6.5.92	REVISED UNIT-88 & 8C AREA	BY
DATE	NO.	REVISION DESCRIPTION
SPRING CREEK FOREST PRELIMINARY OVERALL AREA DEVELOPMENT PLAN		
MACINA, BOSE, COPELAND & ASSOC., INC. FORMERLY R. MARVIN SHIPMAN & CO. CONSULTING ENGINEERS		DESIGN <u>R.W.B.</u> DRAWN <u>W.B.</u> CHECKED DATE <u>JAN. 4, 1988</u> JOB NO. <u>C-4316</u> SHT. <u>1</u> OF <u>1</u>
415 BRESPOST DR. SAN ANTONIO, TEXAS

RE: Spring Creek Forest POADP, Plan #91

Re: Spring Creek Forest P.O.A.D.P. (Revised)

Reference is made to the Preliminary Overall Area Development Plan (POADP) for Spring Creek Forest (File #83-19-63-04) submitted for staff's review. Said plan was jointly reviewed by Planning and Traffic Engineering staff. Our review was concentrated on areas for which plats have not been approved or recorded.

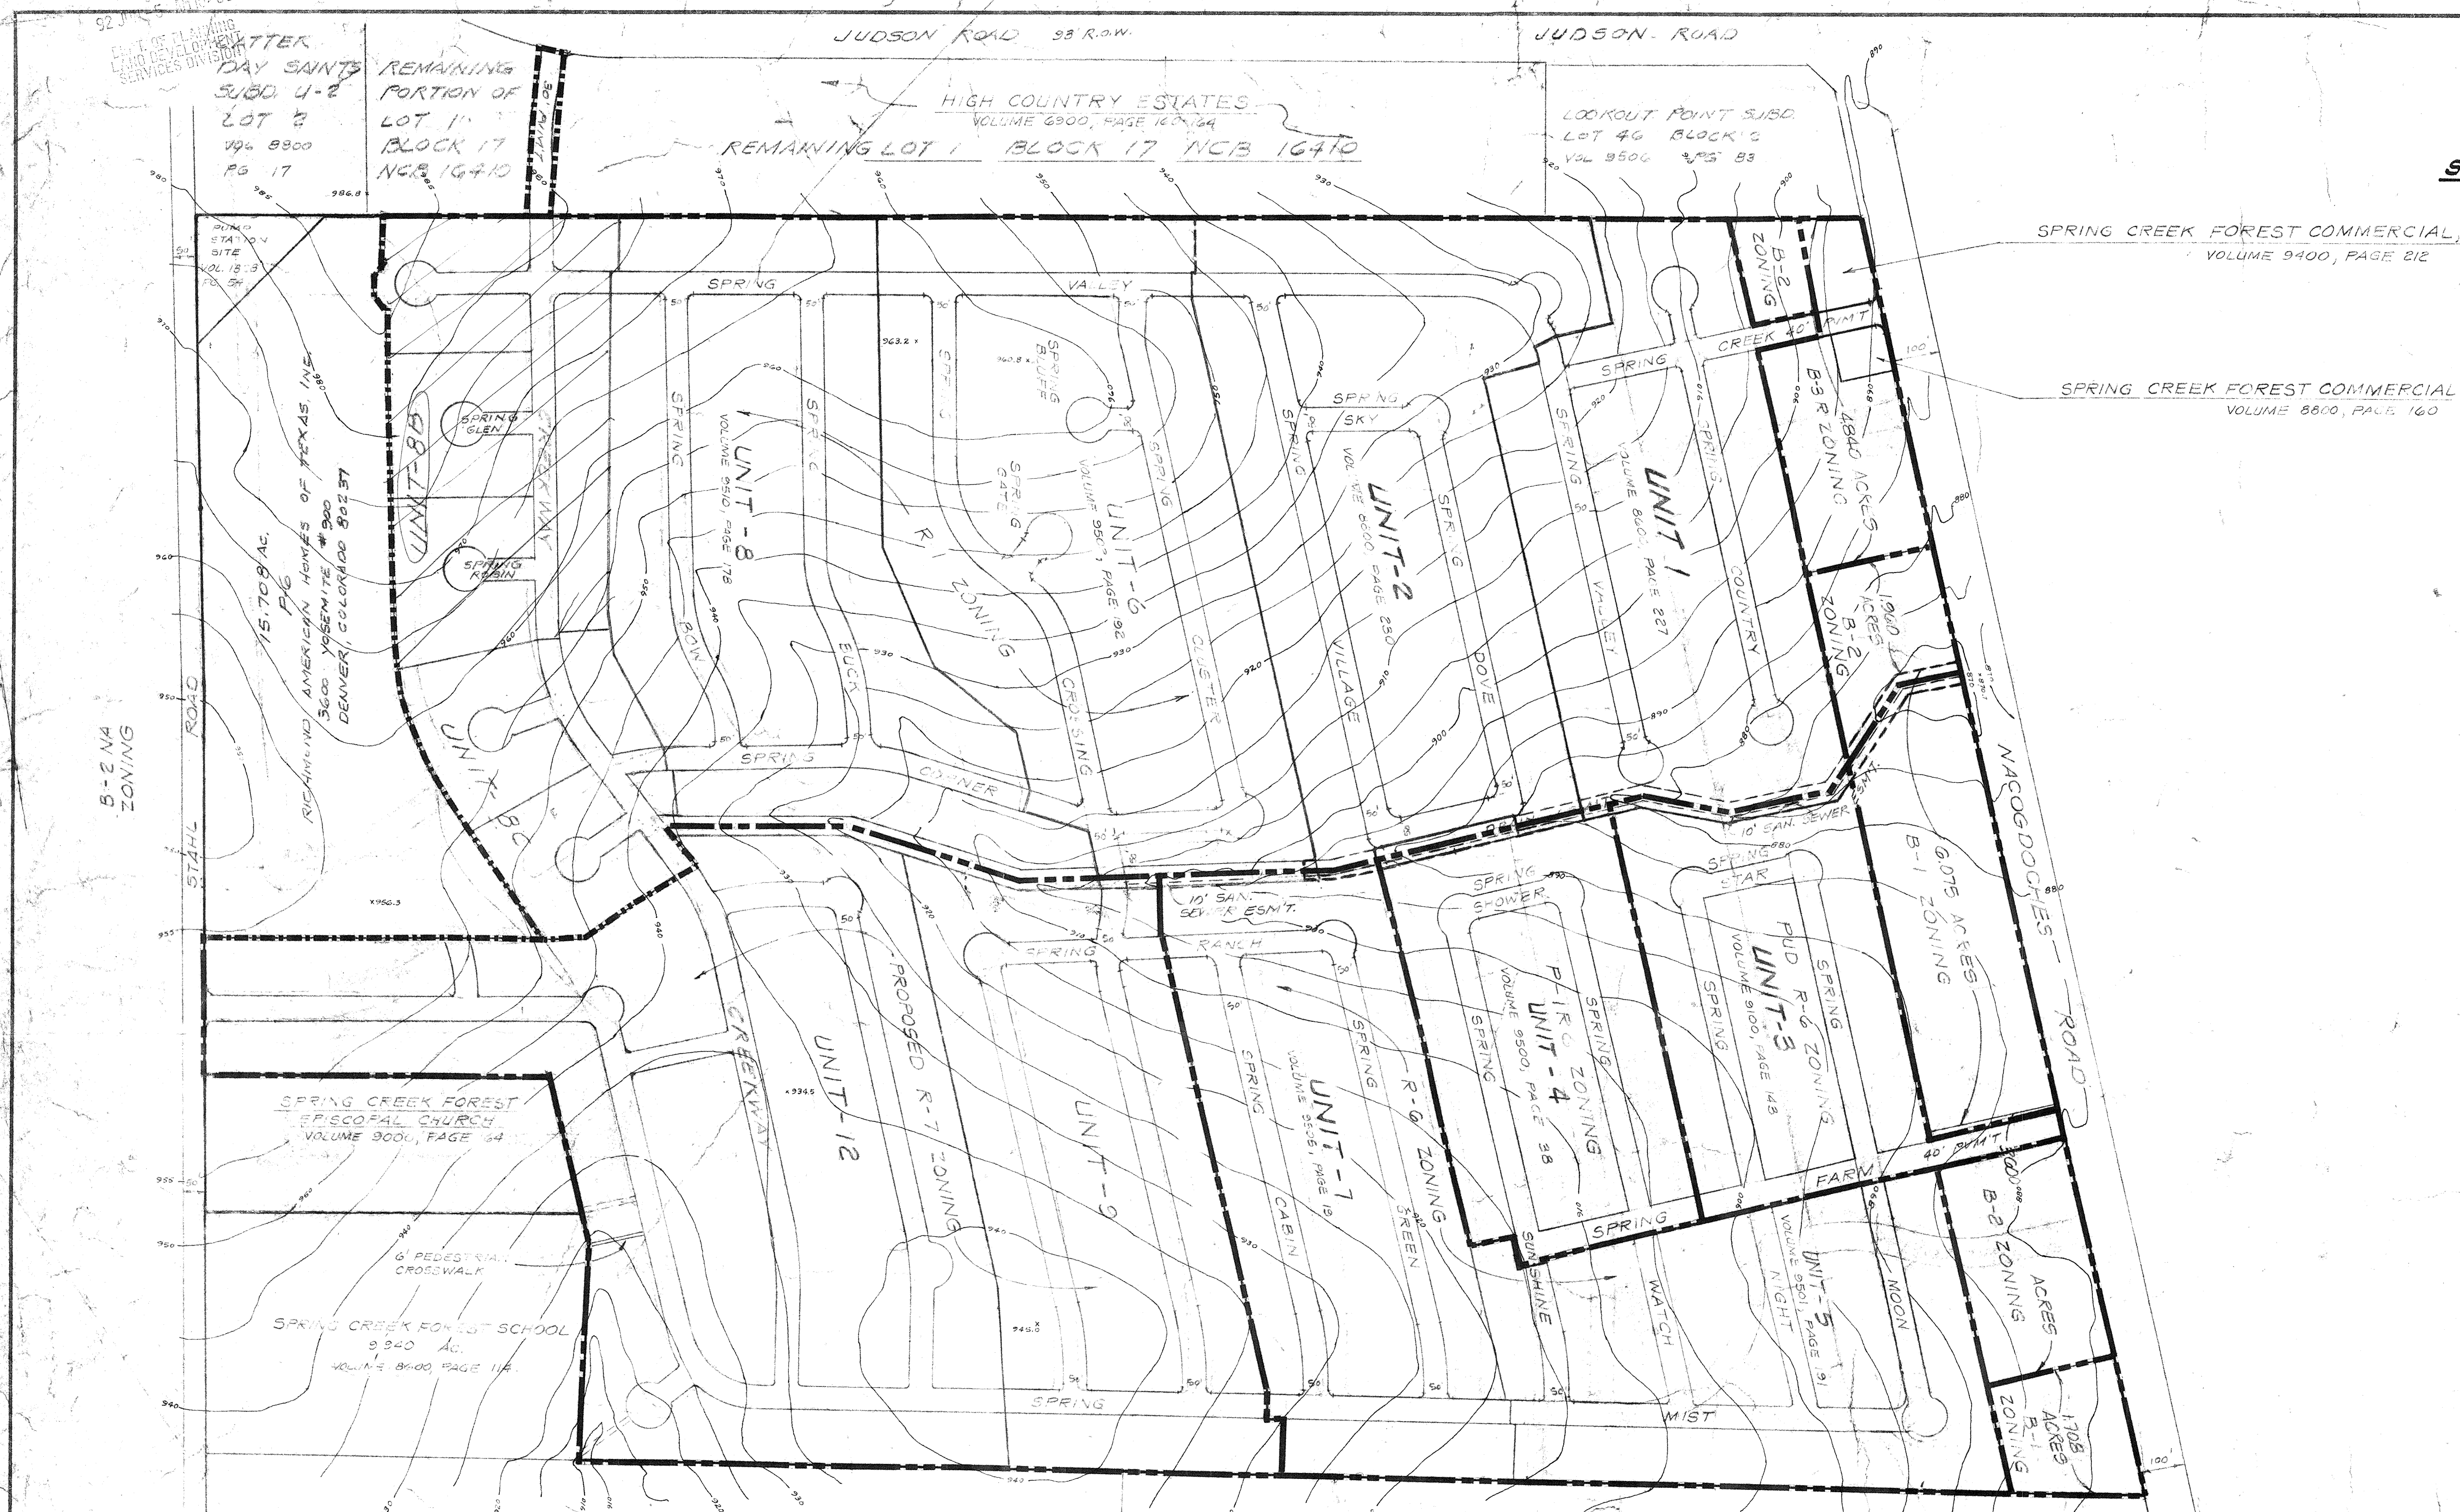
Staff notes that Stahl Road is on the Major Thoroughfare Plan as a Secondary Arterial 86' foot Right-of-way. Future platting along this thoroughfare will require street dedication.

The Committee concurs in the proposed extension of Creekway Drive to Judson Road. However, this connection will encourage cut through traffic for vehicles making a right turn from Stahl Road to Judson. This problem was raised by David Abbey, City Traffic Engineer, during a meeting with Roger Bose, Dan Kossel, Eddie Guzman, and myself. The Committee strongly recommends that you consider revising the street layout to avoid a direct connection from Stahl to Judson via Spring Corner and Creekway.

REMARKS: AFTER DISCUSSIONS BETWEEN ROGER BOSE AND ANDY BALLARD TO DIVERGE TRAFFIC SO AS NOT TO PROMOTE A DIRECT ROUTE FROM STAHL RD TO JUDSON RD VIA SPRING CORNER TO CREEKWAY, A VERBAL APPROVAL TO OUR REVISED P.O.A.D.P. BY ANDY BALLARD WAS GIVEN 5-7-91. THEREFORE, I RESUBMIT THIS P.O.A.D.P. FOR YOUR REVIEW.

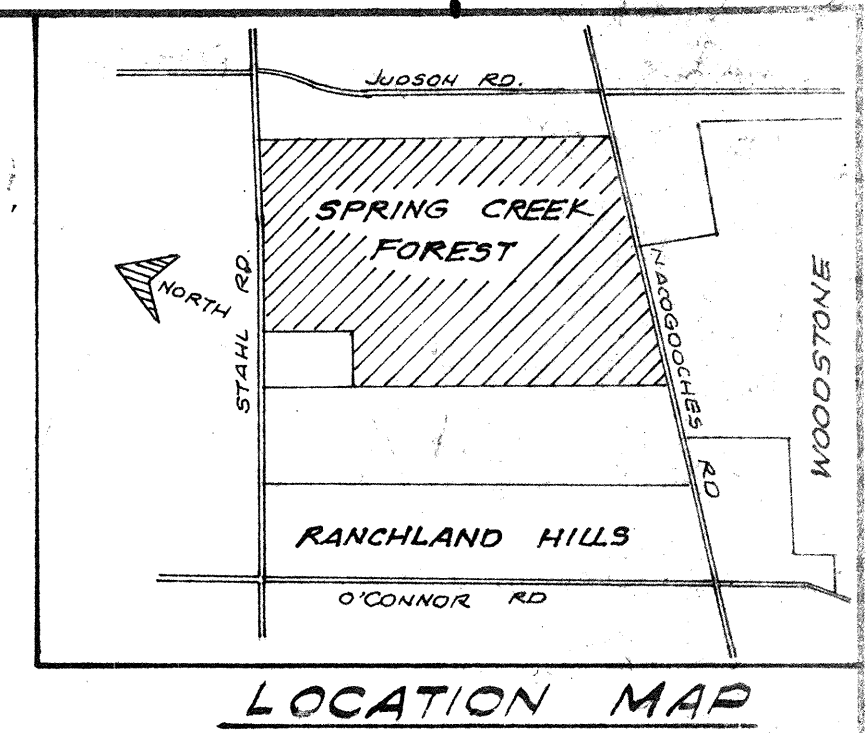
☒ Comments: The revised plan has been reviewed and staff has no objections to the amendments. However, as initially recommended, staff believes that provisions for a stub street to the southwest is still necessary in accordance with Section 36-10C of the Subdivision Regulations.

The result of the review concludes that the proposed scheme is in general compliance with Chapter 36 of the City Code. However, it is recommended that the planned street which ties to Stahl Road and is designated as a local type "B" street on the plan be upgraded to a collector status (60' R.O.W. with 44' paving). This in staffs opinion, will facilitate and introduce expected traffic volumes onto Stahl Road from adjacent areas to be developed. Secondly, it is suggested that in the design work for the area east of the tract identified as a 10-acre school site, that provisions be made for a pedestrian crosswalk connecting the school site with the planned local street 50' R.O.W. to the south-east. Staff believes that in the interest of safety to and from school, the recommended proposal would be conducive to the overall planned development. Therefore, we urge you to take this into consideration.

Another issue addressed is the lack of a stubbed street to the southwestern limits of the overall scheme. Given this, it is recommended that at least one stub street be provided as set forth by Sec. 36-10(c) of the Subdivision Regulations. This would allow the future projection of the street to the adjoining area which would interconnect with expected land to be developed.
